TRI-PARTY AGREEMENT

Change Notice Number TPA-CN- 661	TPA CHANGE NOTICE FORM	Date: July 27, 2015
Document Number, Title, and Revision: Removal Action Work Plan for the Deactivation, Decontamination, Decommissioning, and Demolition of the Plutonium Finishing Plant Complex, Revision 0		Date Document Last Issued: July 2014
Originator: W.G. Cox		Phone: 372-9345

Figure 5-1. Project Schedule

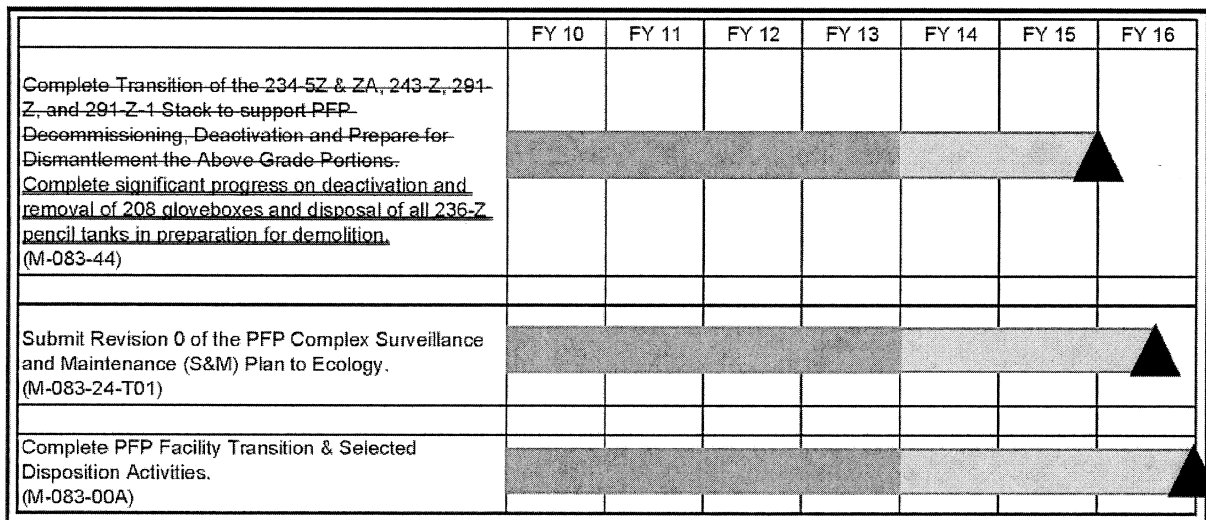
Modification of Figure 5-1 to update TPA Interim Milestone Wording Change per TPA Change Form M-83-15-01.

Figure 5-1 on page 5-1 text is modified to match Milestone M-083-44 language per TPA Change Form M-83-15-01 'Modify facility disposition activities of milestone M-083-44 to reflect a safer, more efficient sequence of transitioning the above-grade portions of the PFP facilities to deactivation and demolition'.
